**LOWER GWYNEDD TOWNSHIP
PLANNING COMMISSION
MEETING AGENDA
May 20, 2026
Public Meeting**

ATTN: Planning Commission
DATE: May 15, 2026
FROM: Jamie P. Worman, Assistant Township Manager *Jamie Worman*
SUBJ: Rise Up Towers- Cell Tower Waiver of Land Development Request #26-07

Reference: Rise Up Cell Tower
Land Development Waiver Request – Review 1
TMP Nos. 39-00-00229-00-2 & 39-00-015770-00-2

SG-1

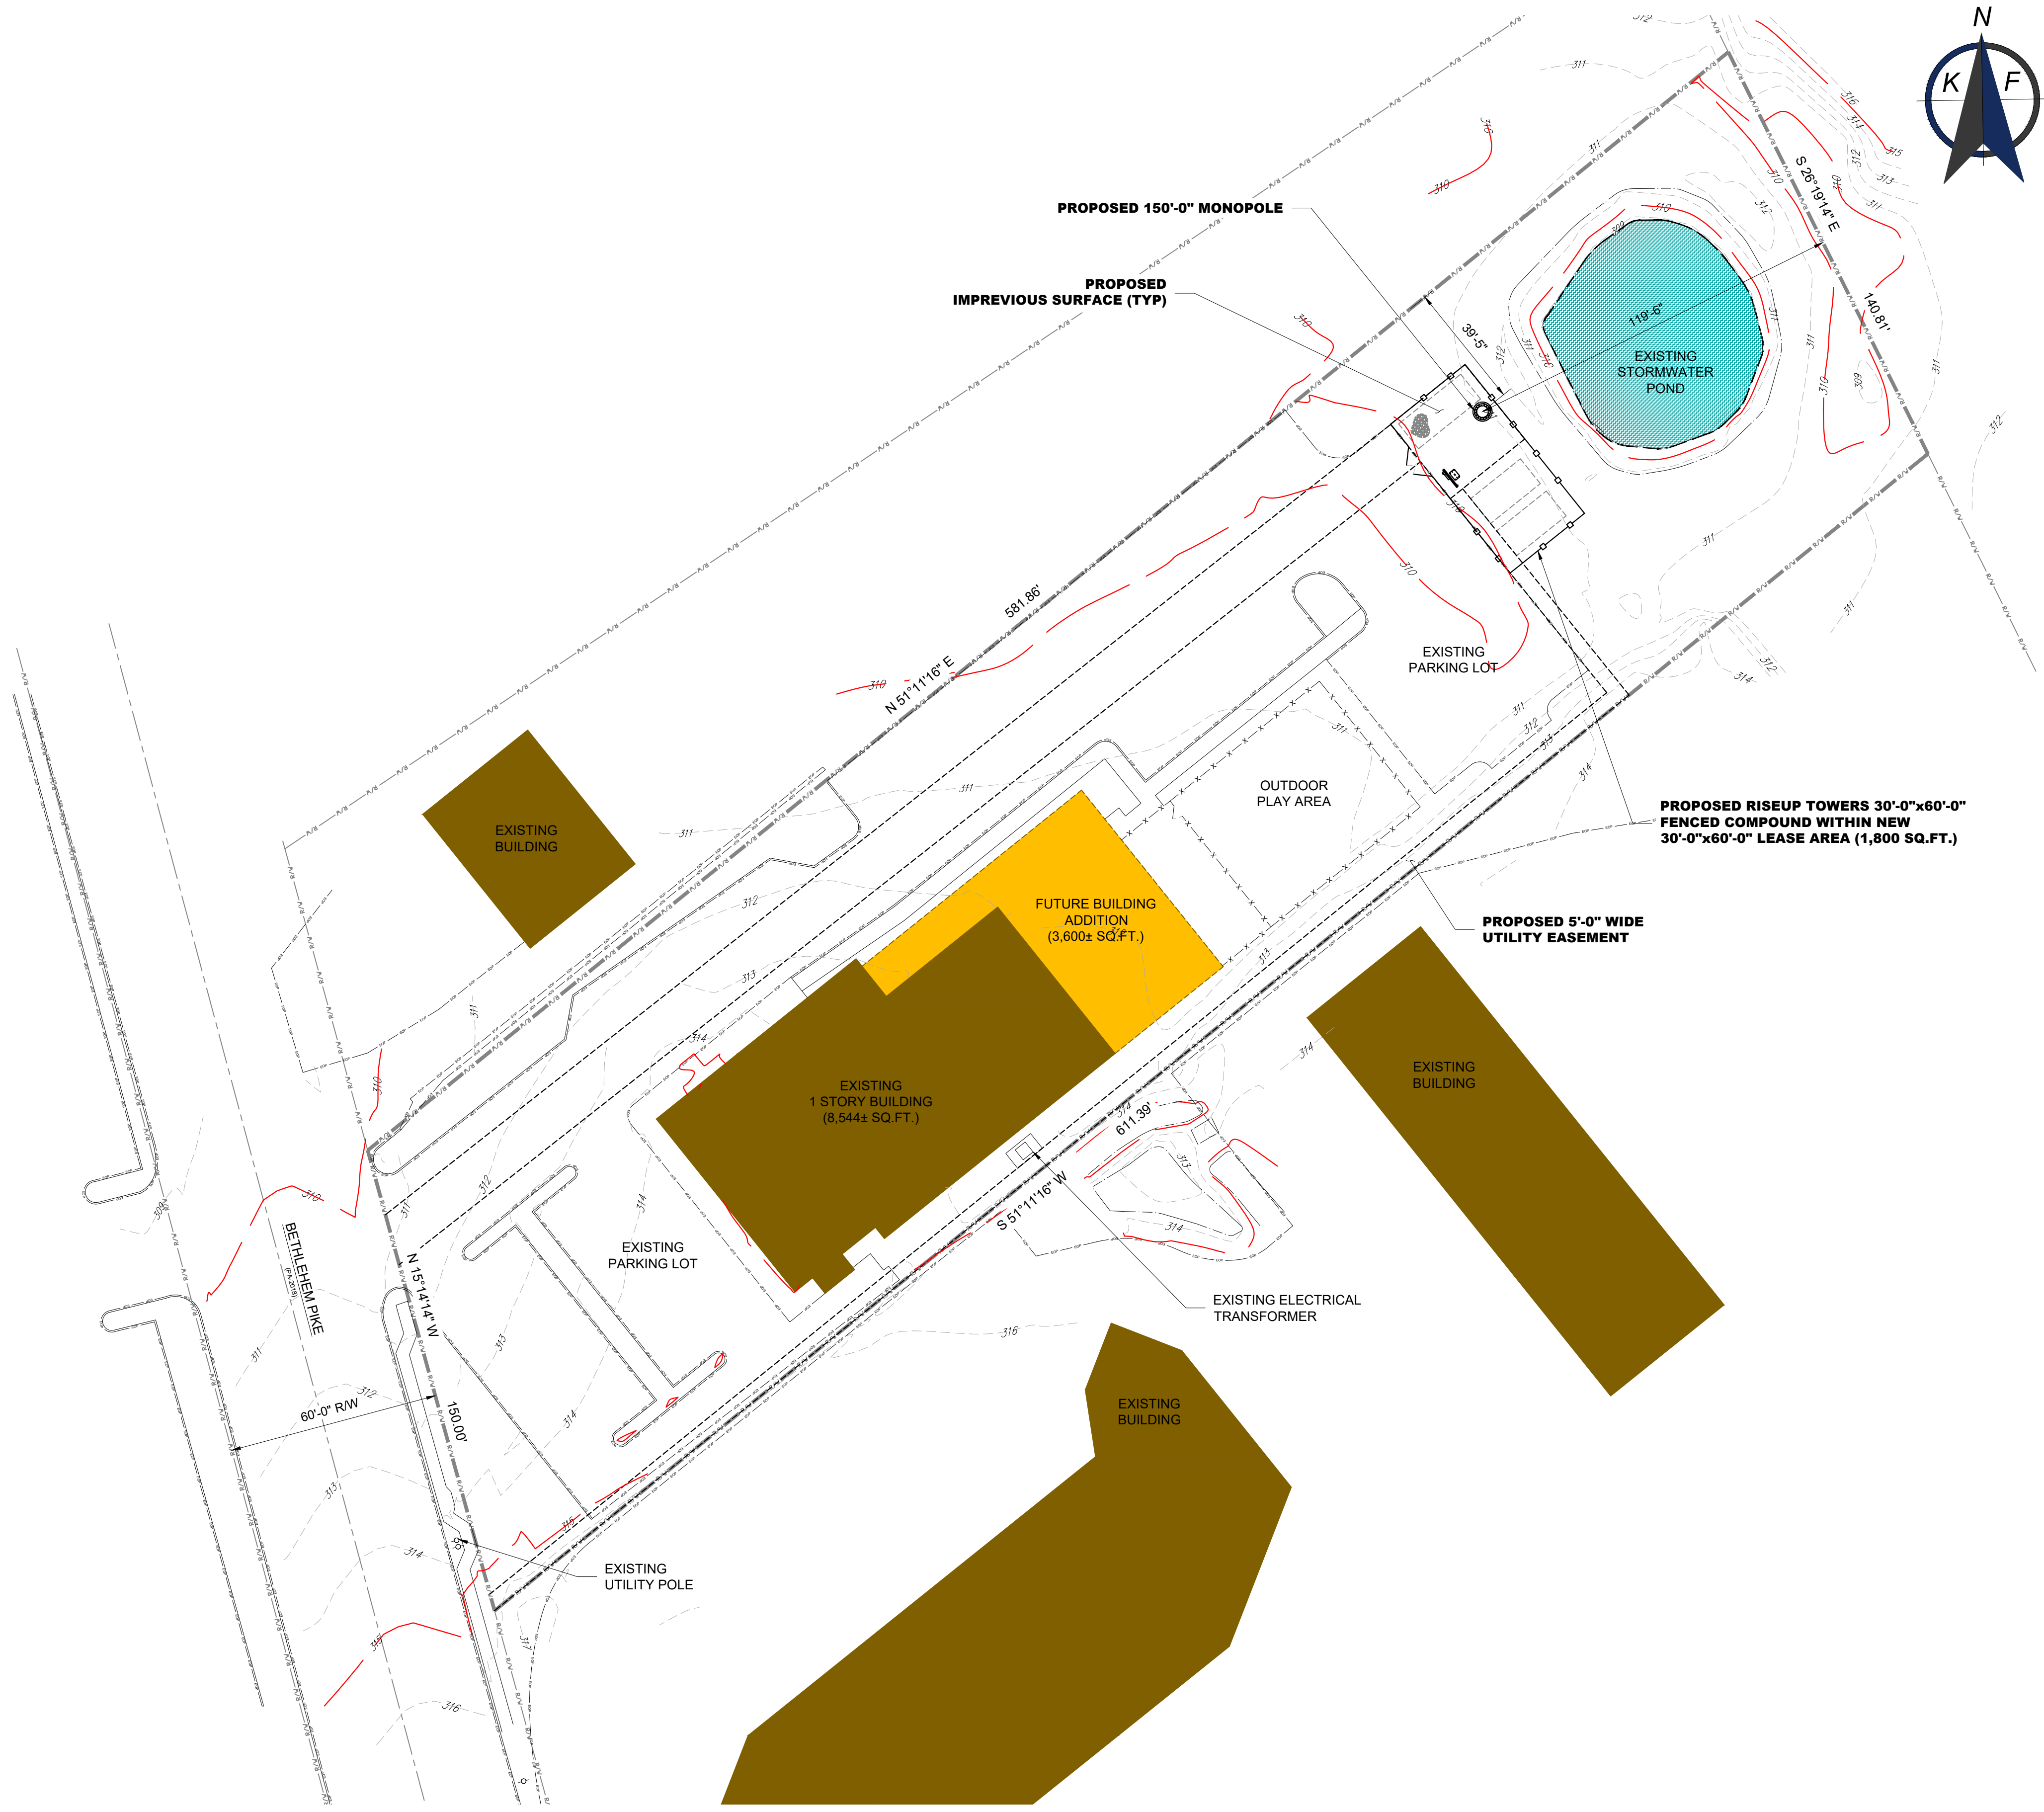
1. §1298.06 – The maximum fence height permitted is 6 feet. We note that the plans propose an 8-foot high wooden fence around the pad area for the monopole. The Applicant will be required to obtain a variance for the proposed fence height.

1. We note that the plans propose a 5' wide utility easement for the underground electric and telecommunication lines. All utility easements are to be a minimum of 10 feet wide. As such, we recommend the Applicant provide a 10-foot wide easement for the proposed utilities or discuss with the Township on the feasibility of a five (5) foot wide easement.

2. We note that the plans propose a wooden fence to buffer the equipment pad for the monopole. However, additional landscaping shall be provided to screen the area from the development on the subject property and the adjacent properties.

3. We note that the access easement is shown on a proposed parking lot configuration that has not been approved. We recommend that the plans be revised to show the existing lot configuration and revise the easement accordingly. The Applicant may consider a blanket easement for access on the property.

4. The Applicant shall provide legal descriptions for the proposed utility and access easements to our office for review and approval. In addition, the metes and bounds of the easements shall be identified on the plans.

5. We note that the plans show the proposed telecommunication line crossing the existing sidewalk within the right-of-way. The Applicant will be required to replace the concrete sidewalk in accordance with Lower Gwynedd Township standards.

6. The plans shall be revised to provide all necessary erosion and sediment controls, including but not limited to silt sock and topsoil stockpile areas. Details of the erosion and sediment controls shall be added to the plans.

SG-1

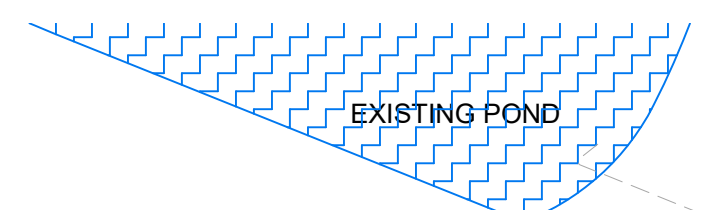
1. We note that the Applicant proposes two separate easements for access and utilities. We recommend that the applicant combine with easement into one for access and utility installation. Additionally, the Applicant shall provide legal descriptions for the proposed utility and access easement to our office for review and the metes and bounds shall be identified on the plans.

2. It is our understanding that tree removal is not necessary for the installation of the monopole pad. However, the Applicant shall be aware that any tree removed that is greater than six (6) caliper inches will be subject to the Lower Gwynedd Township tree replacement ordinance.

3. The utility service trench detail notes that only a 1.5" wearing course on an 8" base course is proposed for paved areas. The details shall be revised to meet the Lower Gwynedd Township standards for paved parking lots.

4. The plans shall be revised to provide all necessary erosion and sediment controls, including but not limited to silt sock and topsoil stockpile areas. Details of the erosion and sediment controls shall be added to the plans.
